STAFF REPORT

Subject: Jerde Single Family Dwelling Addition; 192 Foothill Drive; Zephyr Cove, Douglas County, NV; Assessor's Parcel Number (APN) 1318-10-310-045; TRPA File Number ERSP2023-0906

DRAFT PERMIT

North Elevation

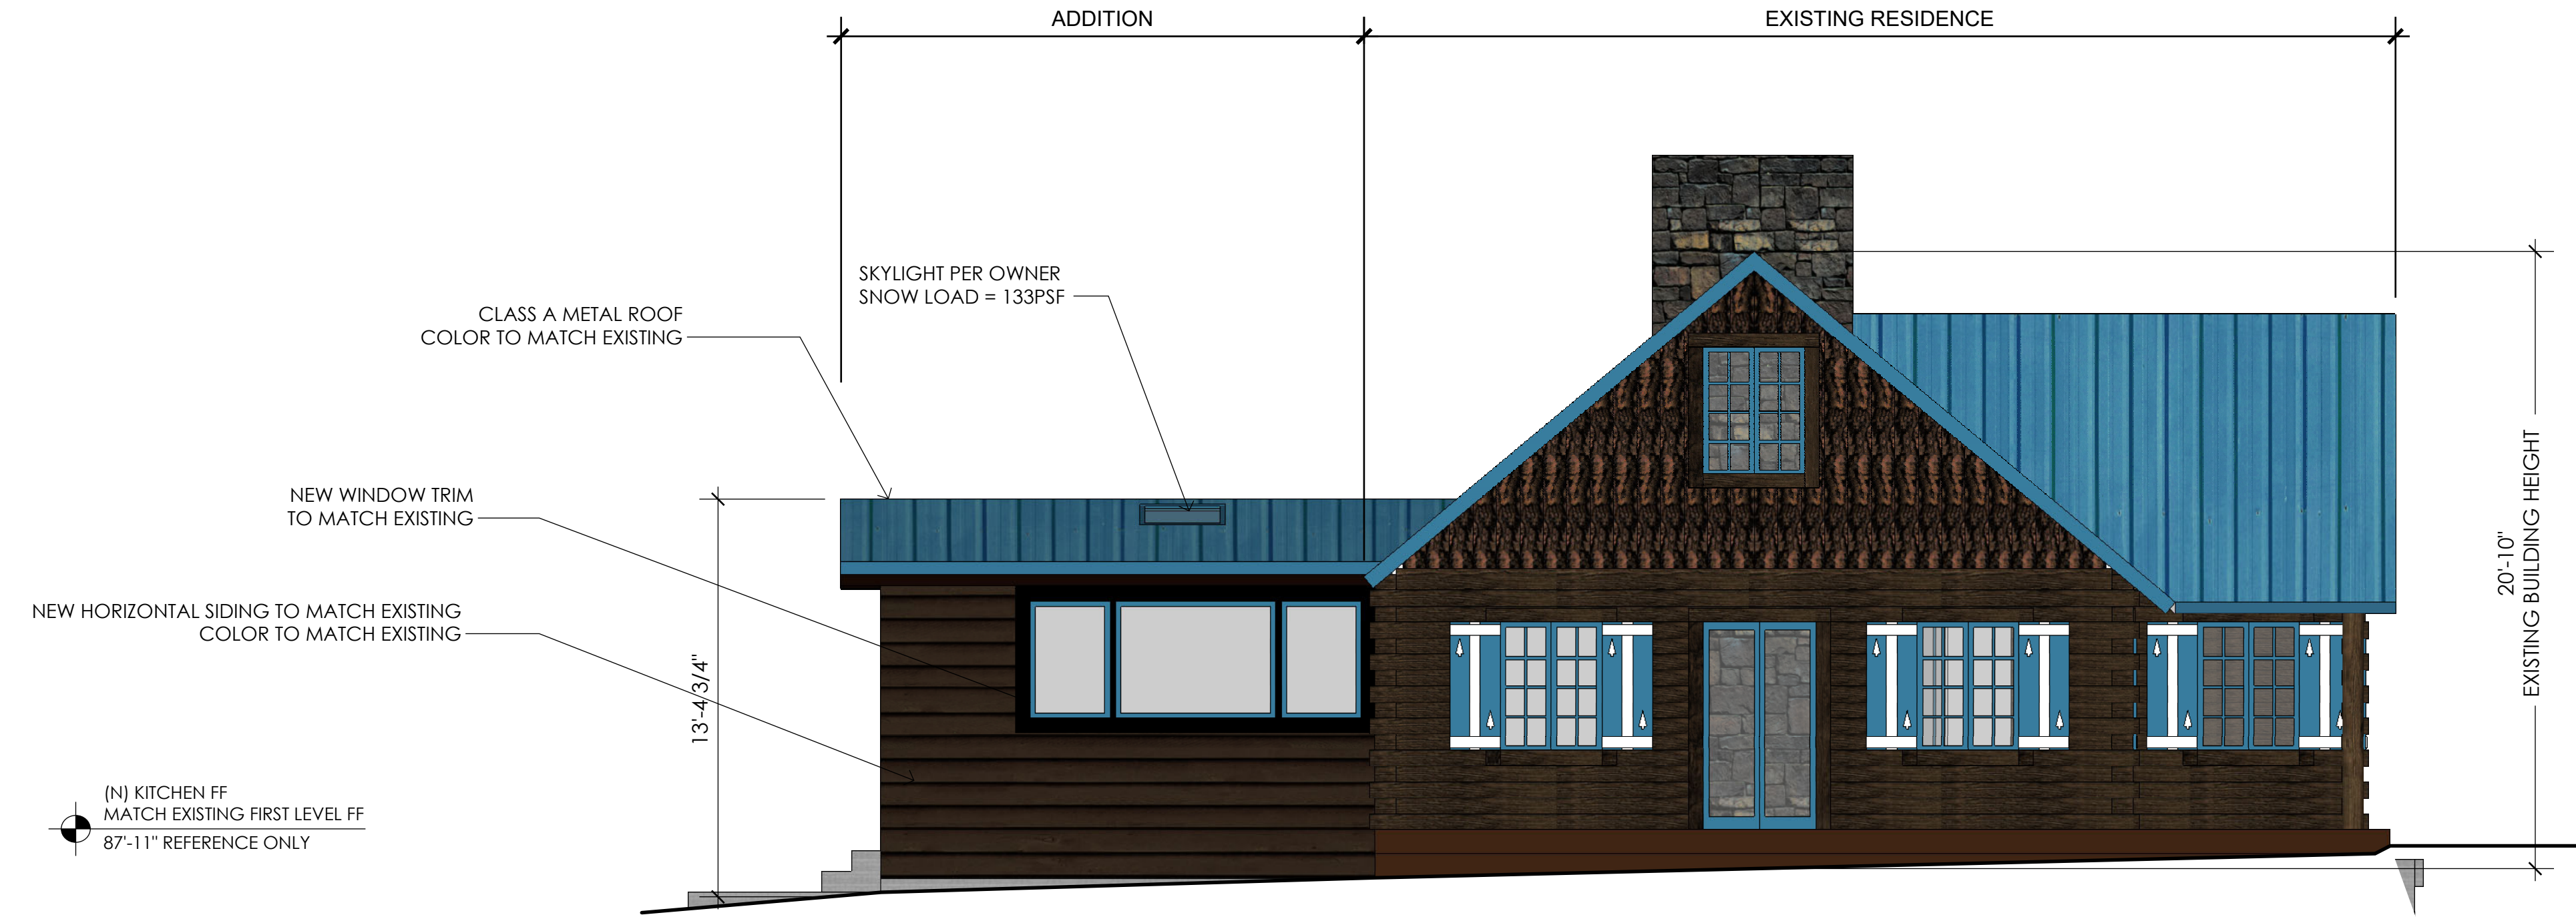
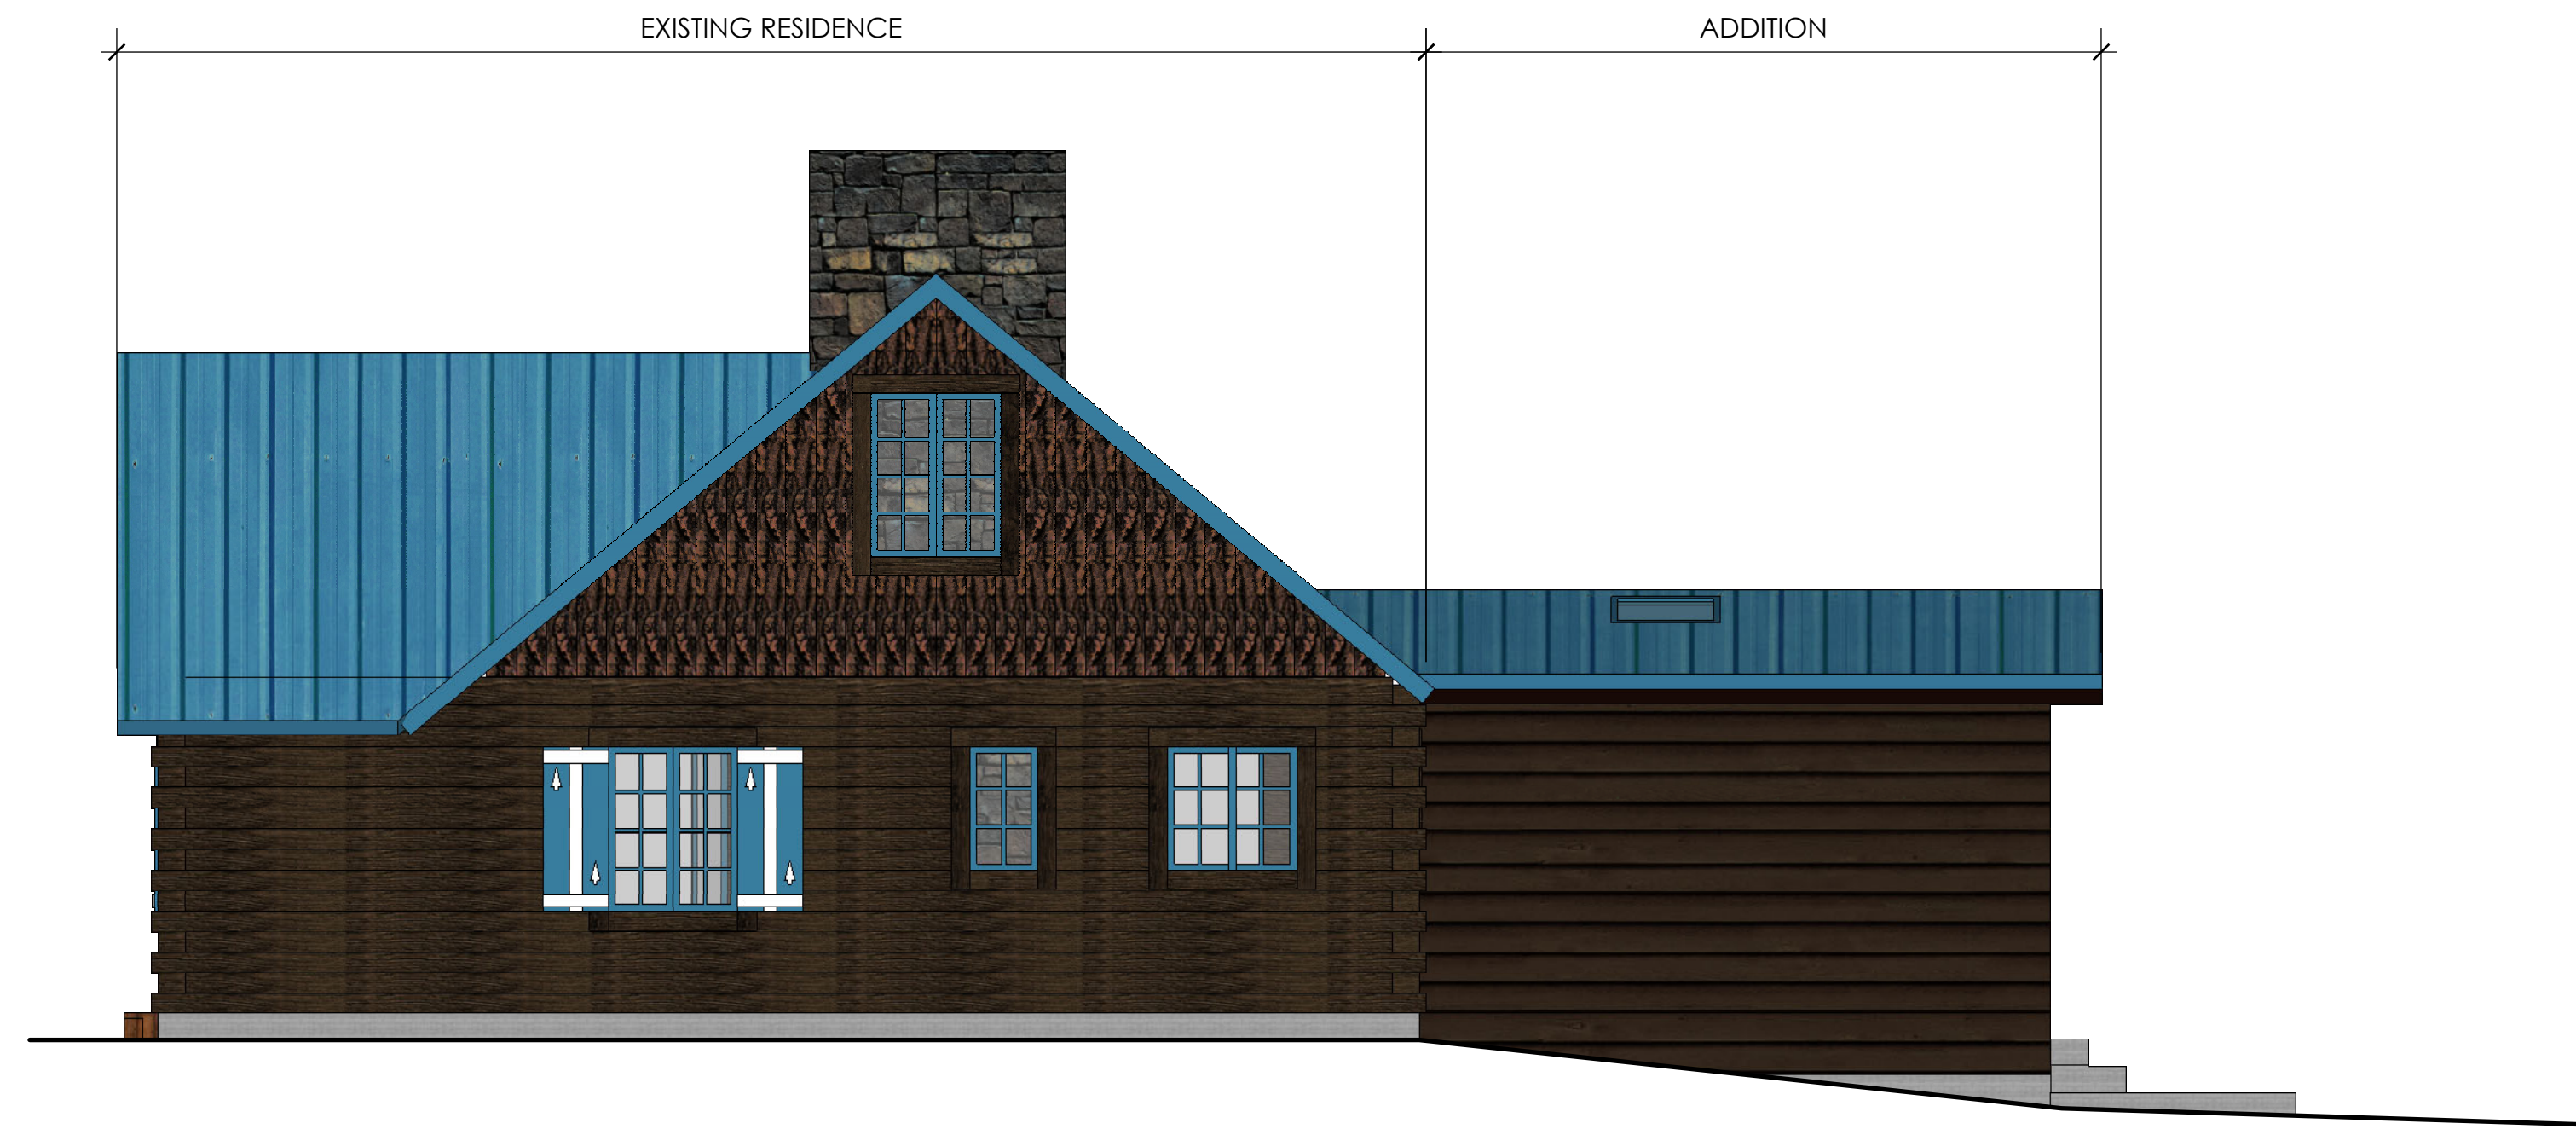
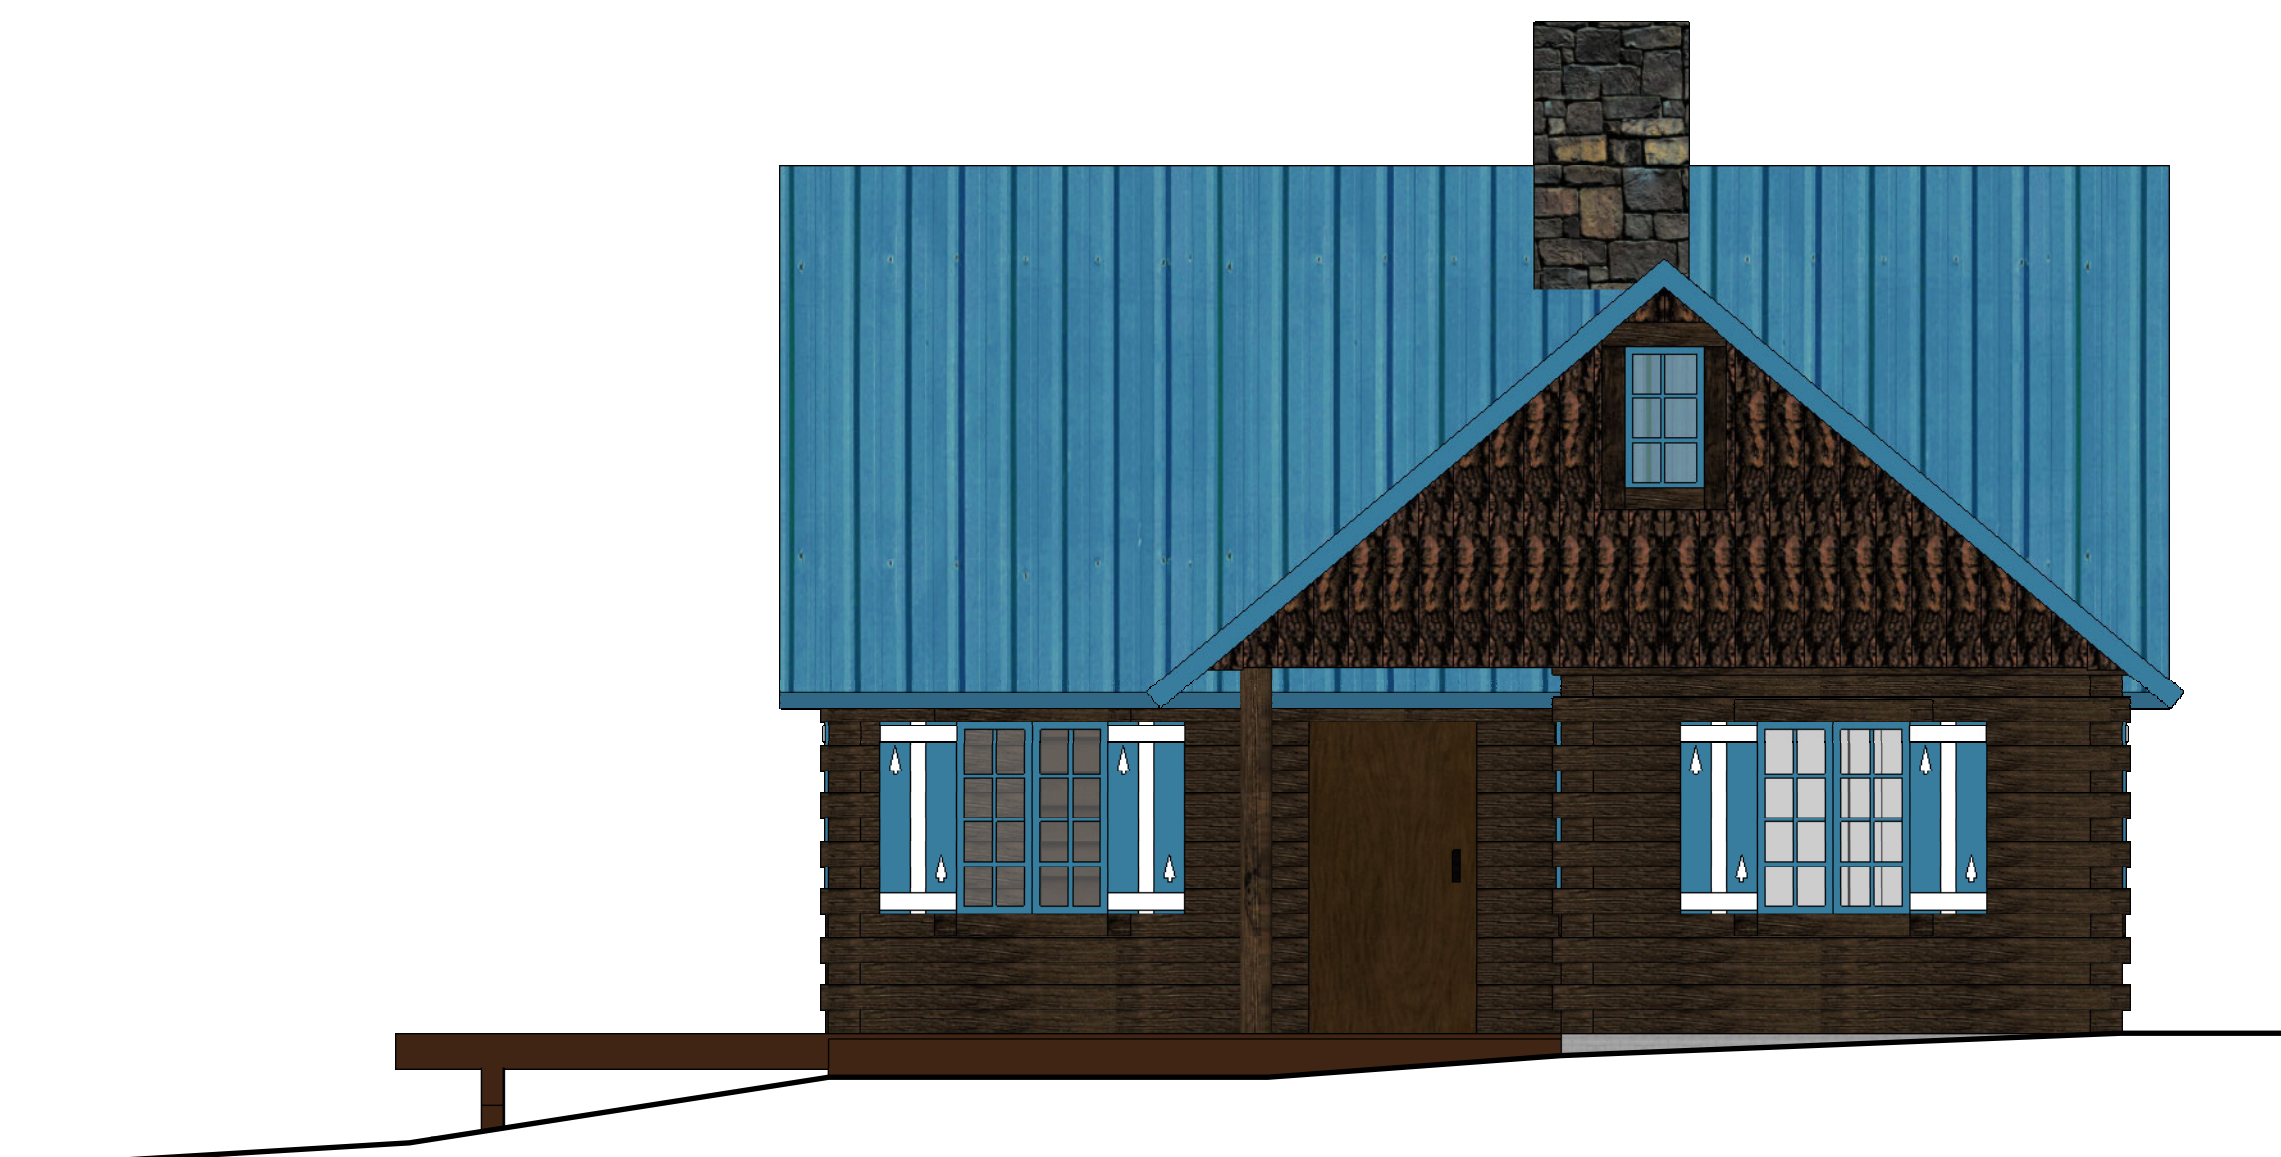
- (8) Parking barriers to restrict parking to approved parking surfaces only.
- B. The elevations shall be revised to include corrected allowed and proposed height calculations based on the revised slope across the building site and the identified new low point of the structure.
